# **UT to Rush Fork Stream Mitigation Project Year 2 (2023) Monitoring Report FINAL**

DMS Project ID No. 100068, DEQ Contract No. 7535

USACE Action ID No. SAW-2018-01171, DWR# 2018-1034

Response to DMS Comments (January 3, 2024) for DRAFT Monitoring Year 2 Report.  
UT to Rush Fork Stream Mitigation Project  
French Broad River Basin: 06010106  
DMS Project #100068  
DEQ Contract #7535

**Figure 3A. Current Condition  
Plan View (CCPV) MY2  
UT to Rush Fork Project  
Haywood County**

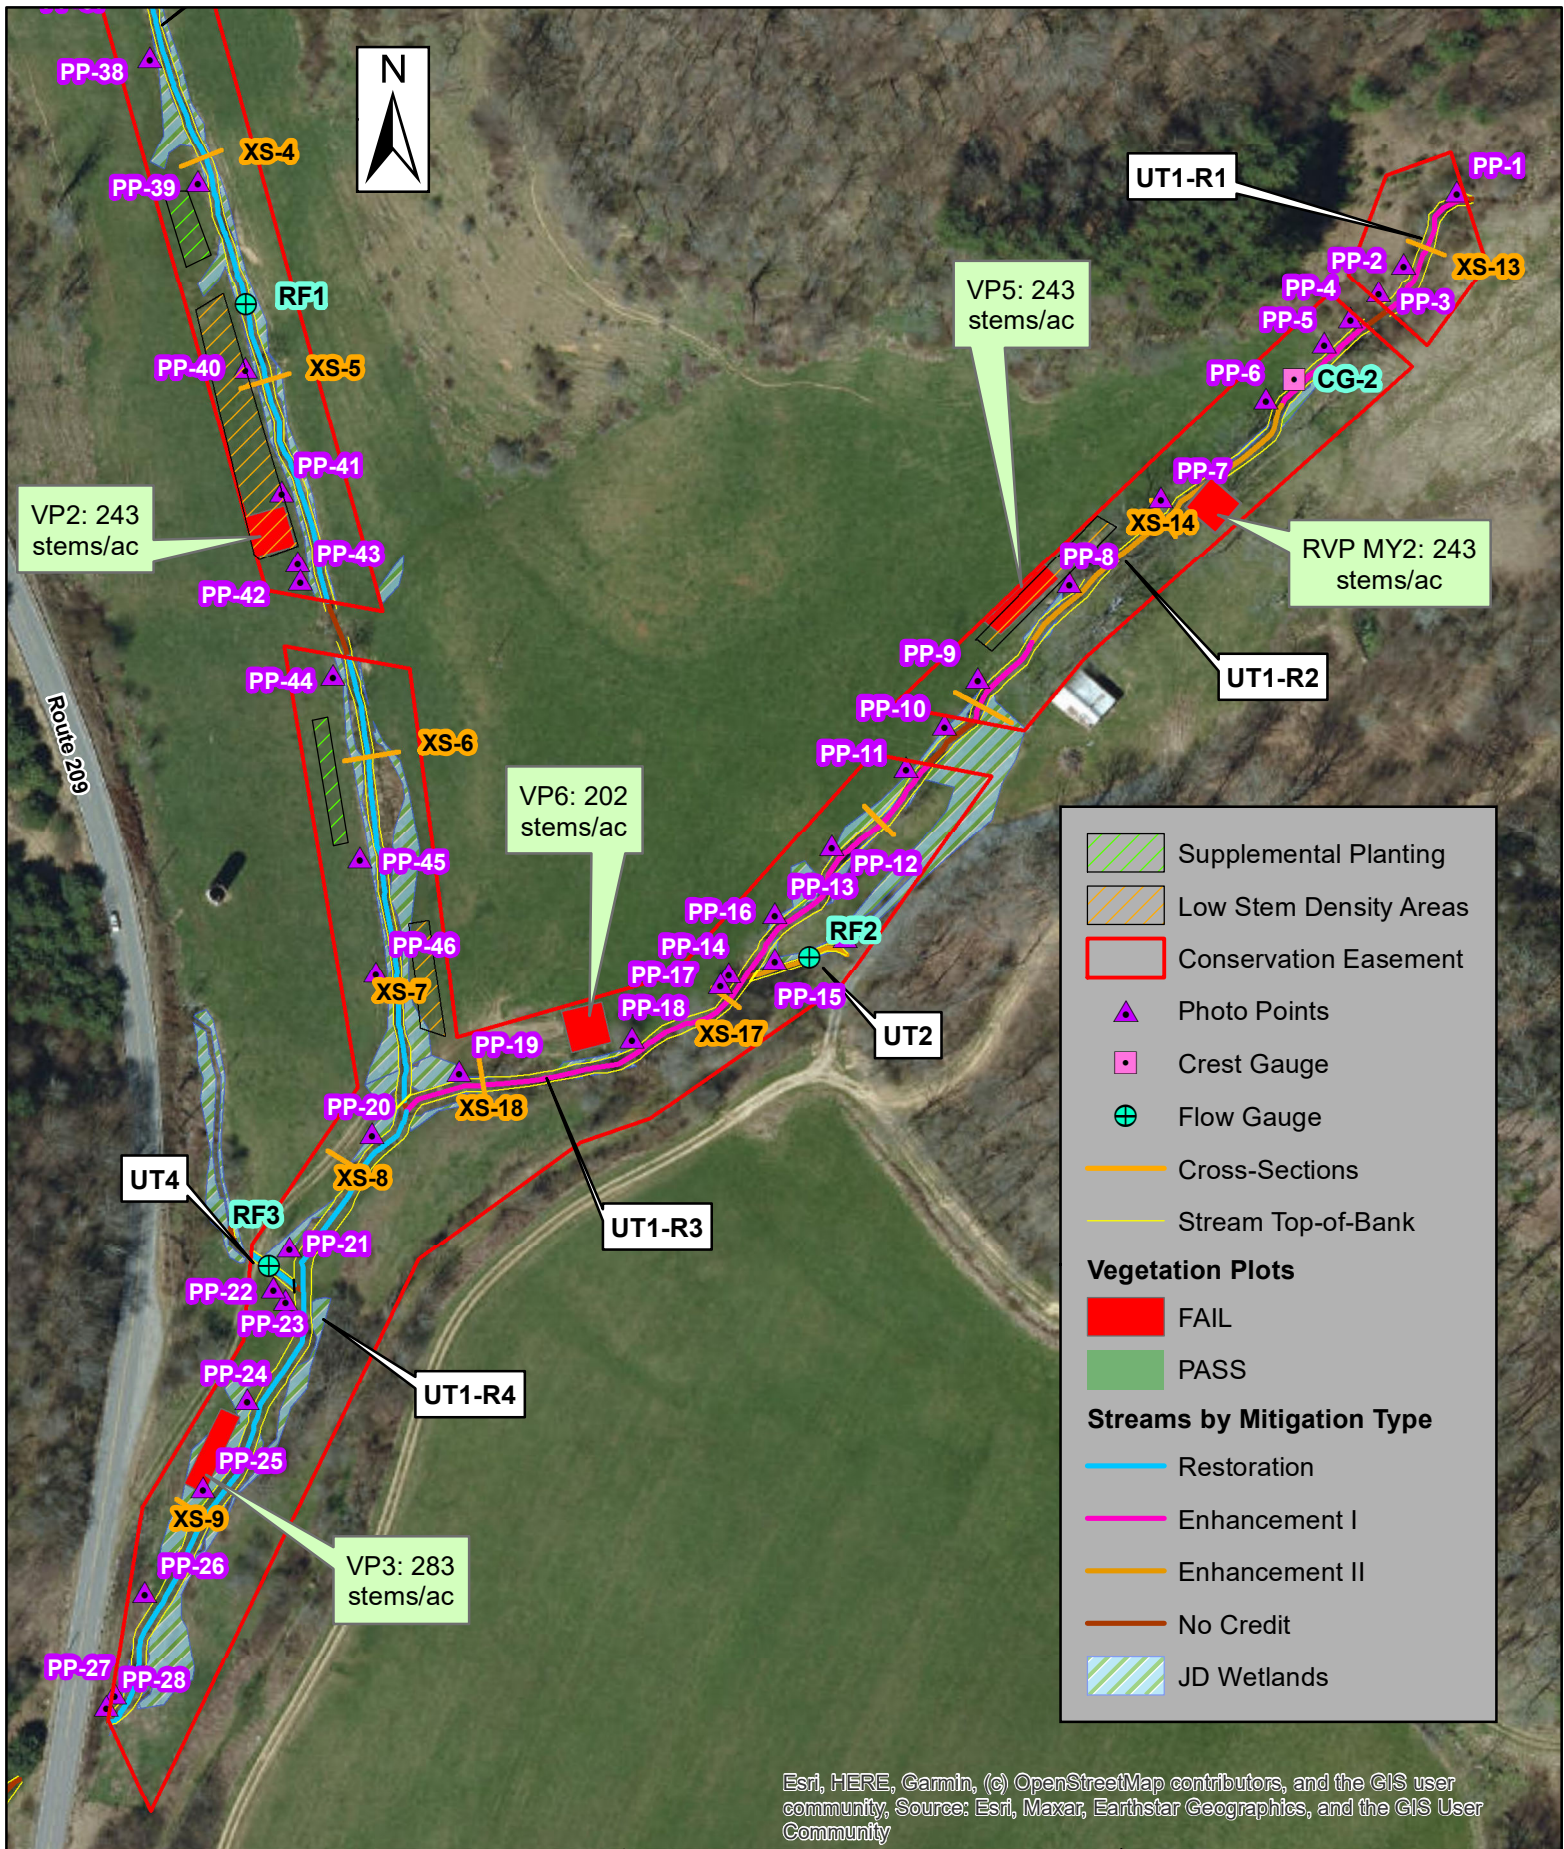
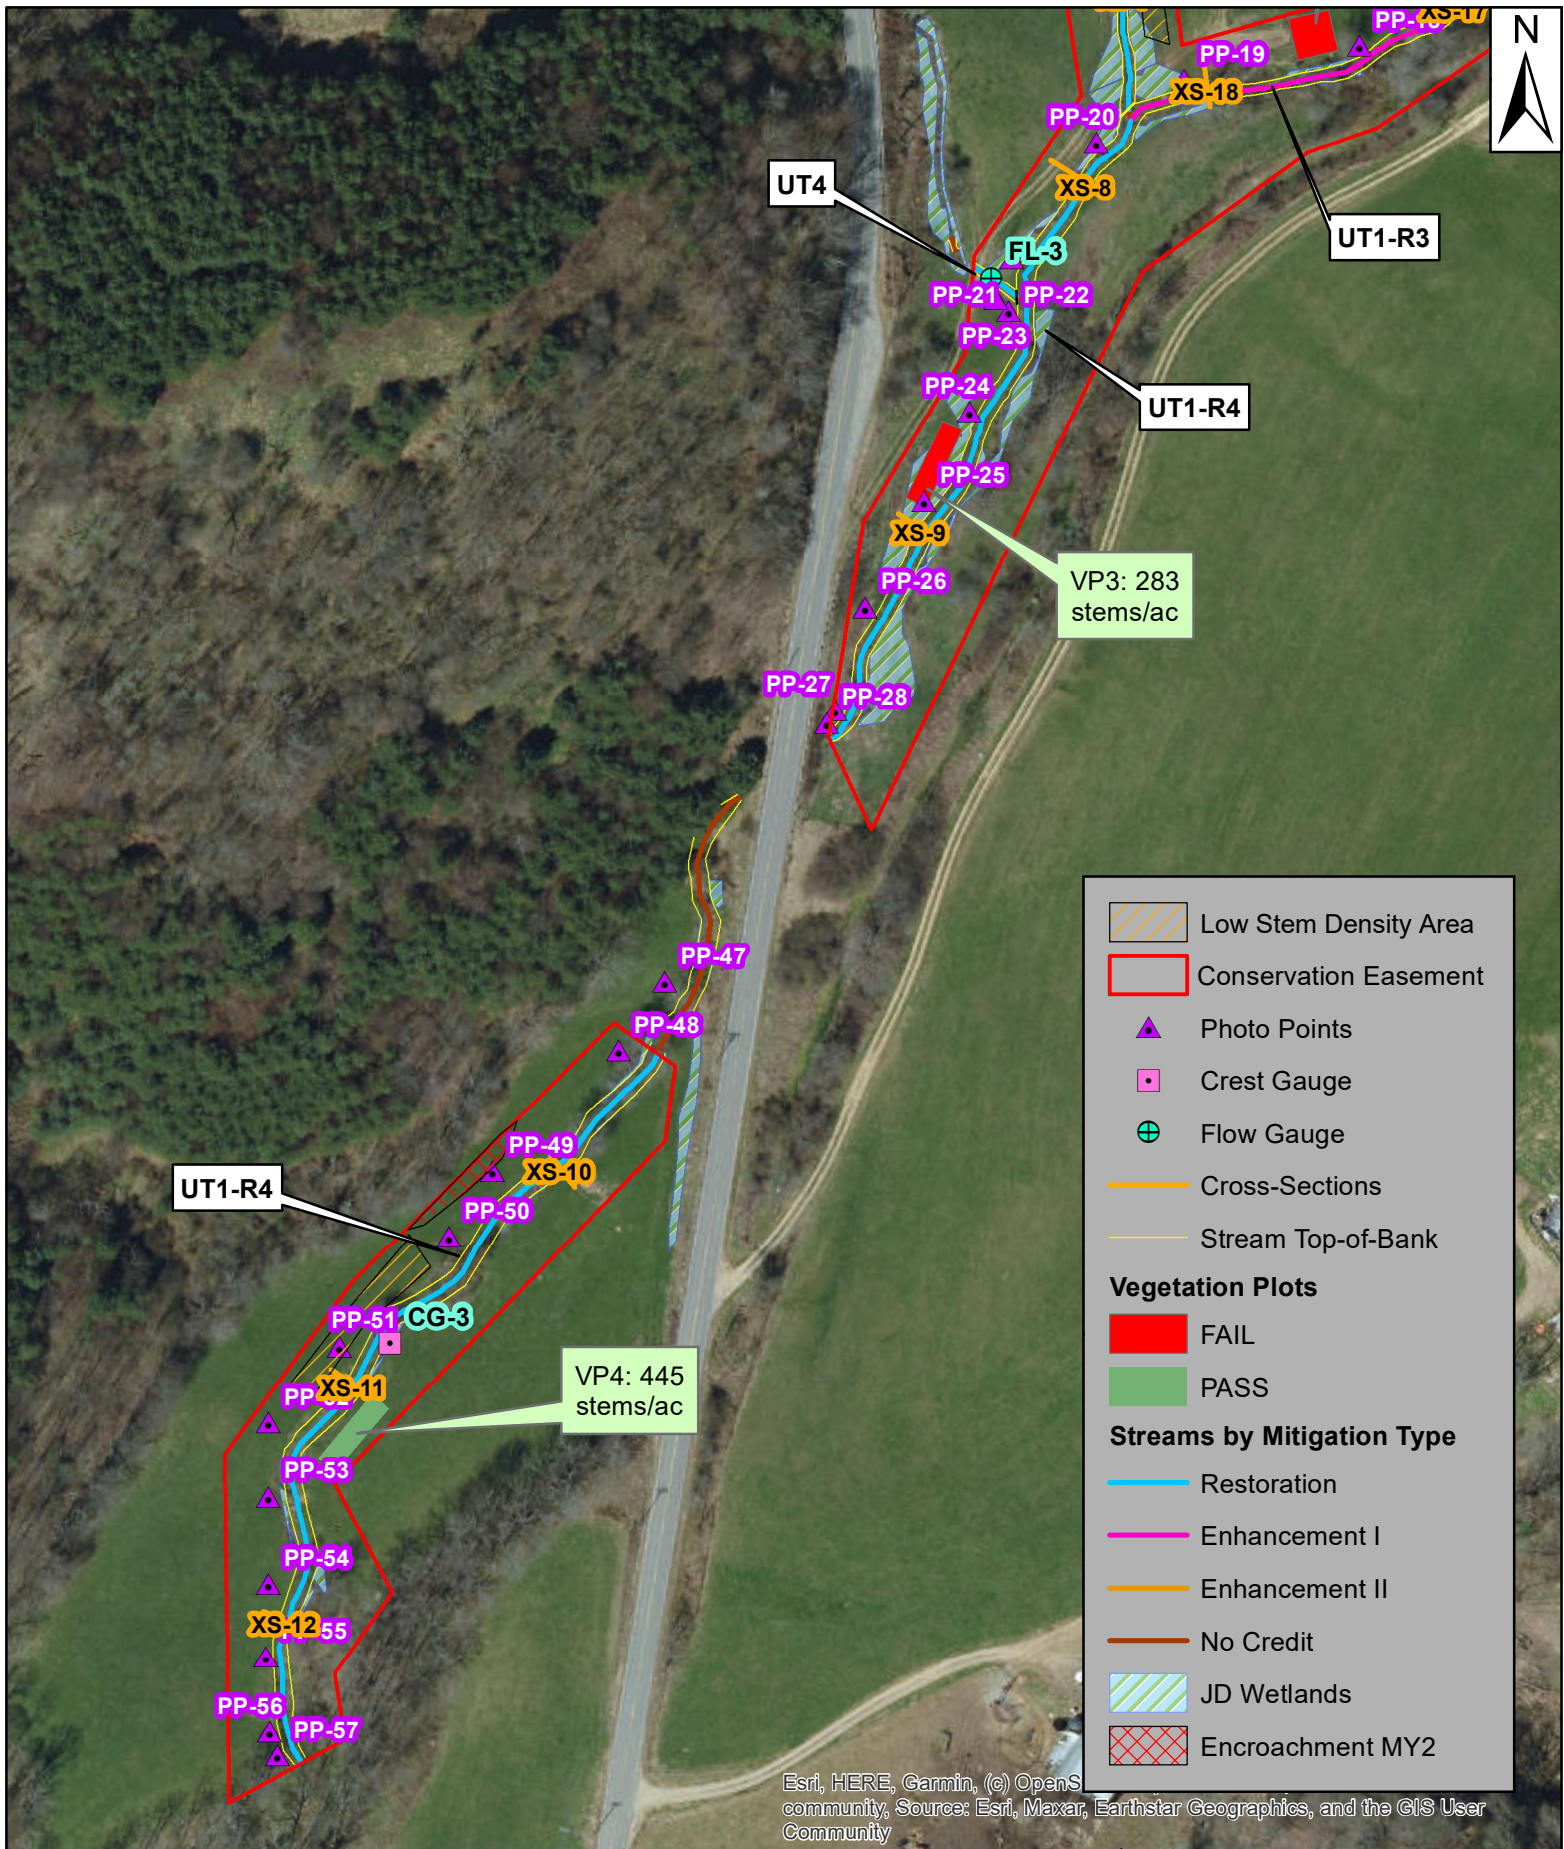
- Current Condition Plan View (CCPV) Maps: Since the VPAs reported are all low stem density areas, DMS recommends updating the map legend to Low Stem Density Areas.

RESPONSE: The map legend has been updated as requested.

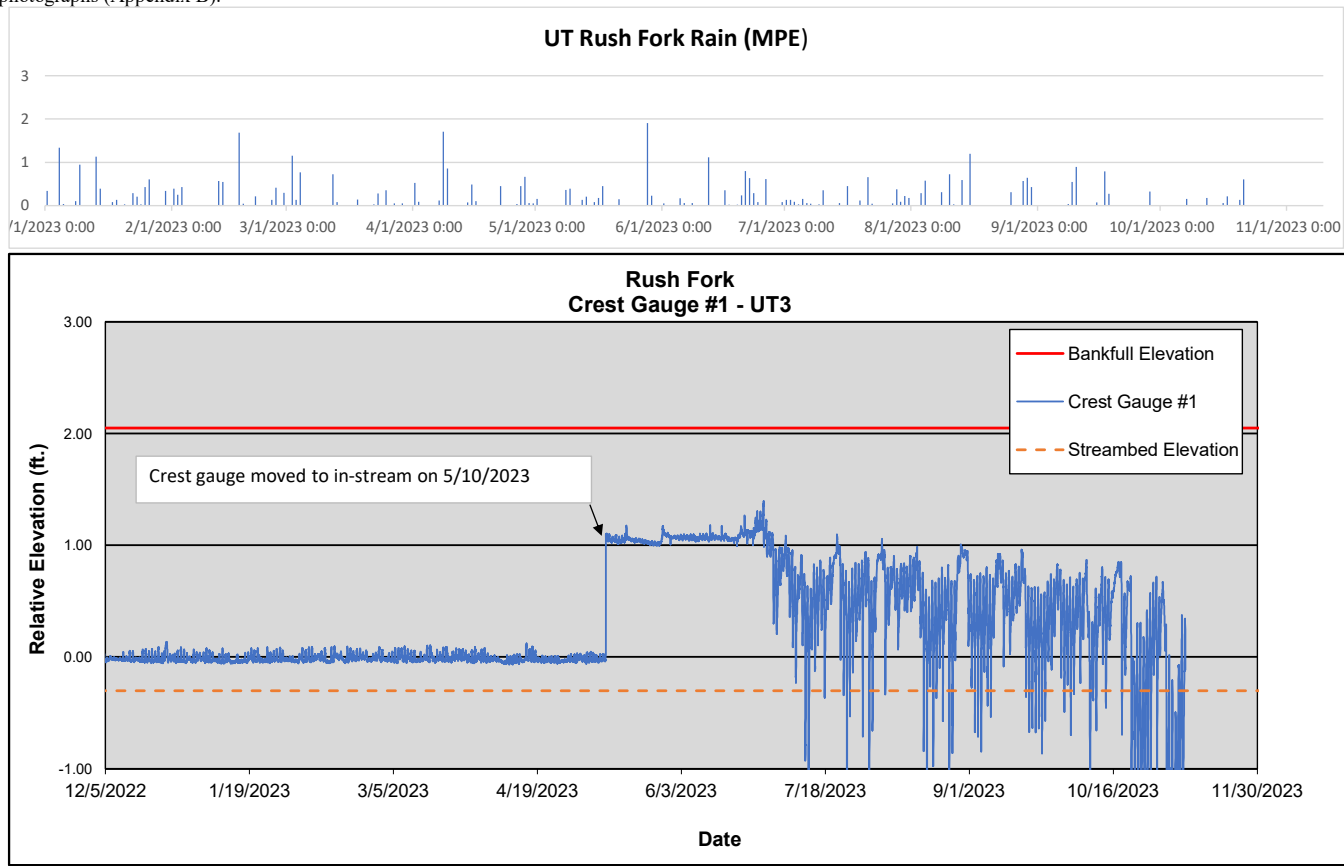
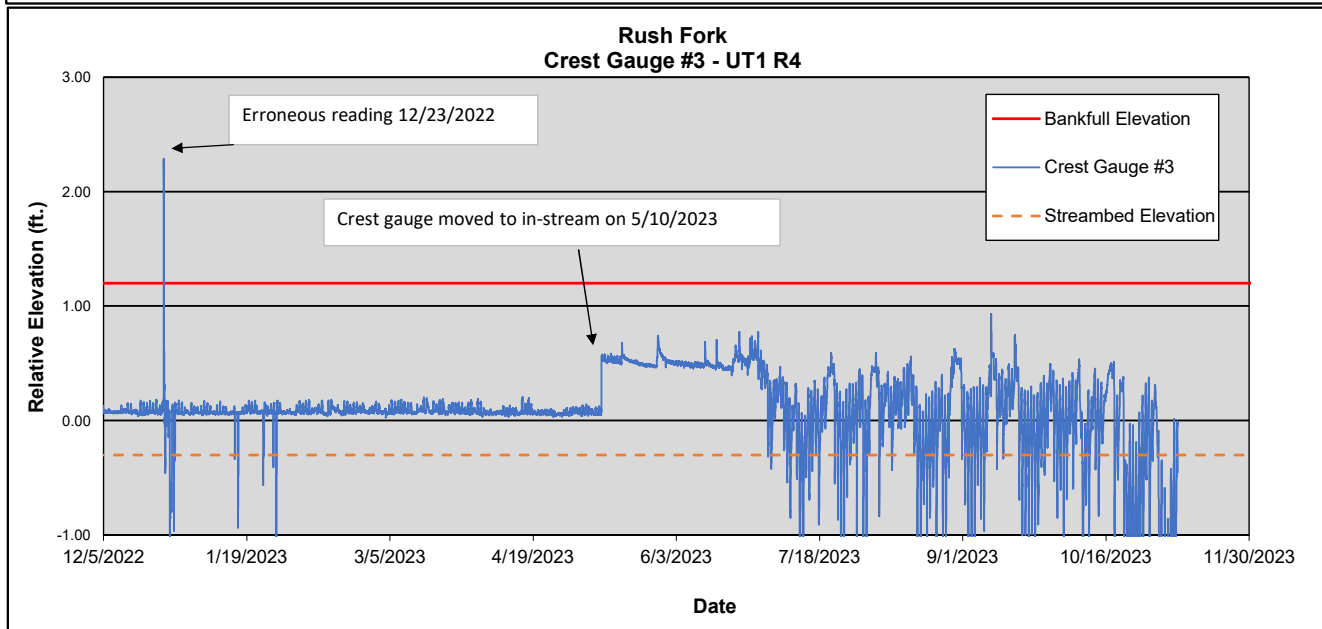
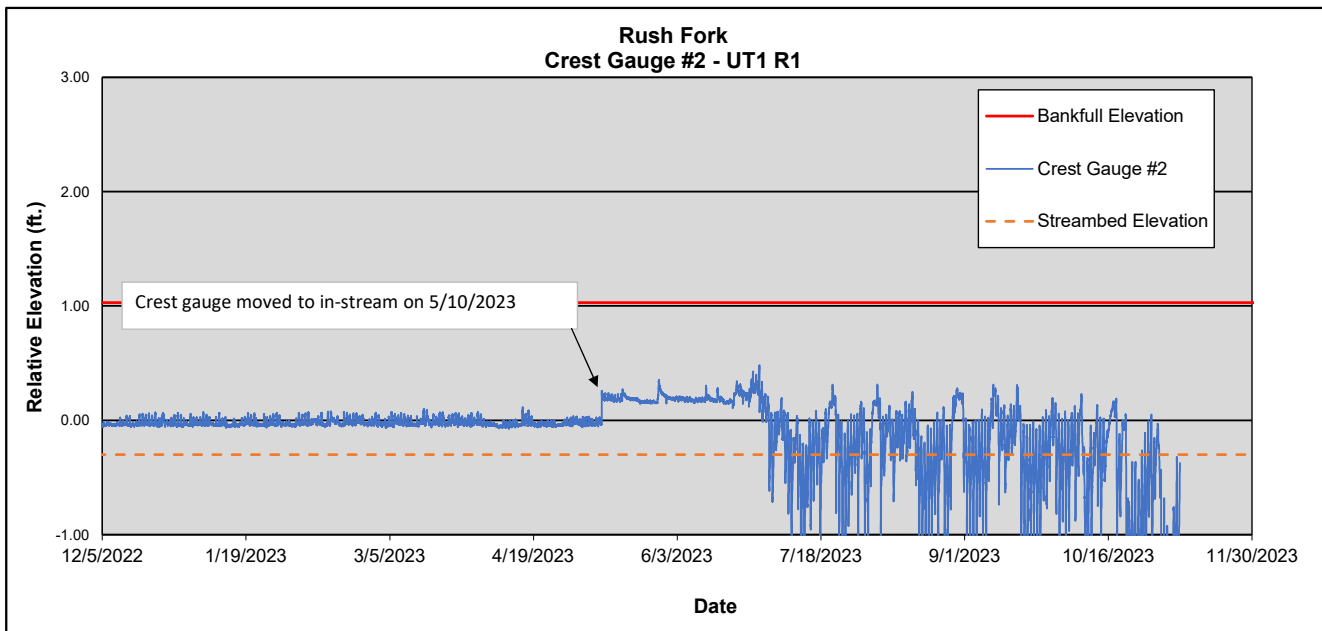
- Bankfull Events & Crest Gauge graphs: Please review and confirm that the graphs and data presented are accurate. It is difficult to determine how the provided crest gauge data correlates with the provided rainfall data; no rain gauge data is provided for the one (1) bankfull event reported in MY3 (2023). Many times, the crest gauge data falls well below the stream bed elevation. Please consider using a different color for the streambed elevation line. Lastly, Gauge is misspelled in the legend for Crest Gauge #2.

RESPONSE: After further evaluation we believe that the bankfull event reported on 12-23-2022 was an erroneous reading as there is no corroborating rain or flow data. This has been called out on the graph and deleted as an event in Table 10. Crest gauge data prior to the relocation of the gauges to in-stream should be disregarded as there were no events recorded and the graph is inaccurate prior to 5-10-2023 based on streambed and bankfull elevation lines. We also believe there may have been a malfunction with the site BARO as both the crest gauges and the flow gauges data takes the same sharp downward trend in late June 2023. This trend falls well below the streambed elevation in most cases which is not possible in reality. Baker staff will download and replace the BARO if necessary, early in MY3. Lastly, the spelling error and the streambed elevation line have been revised as requested.
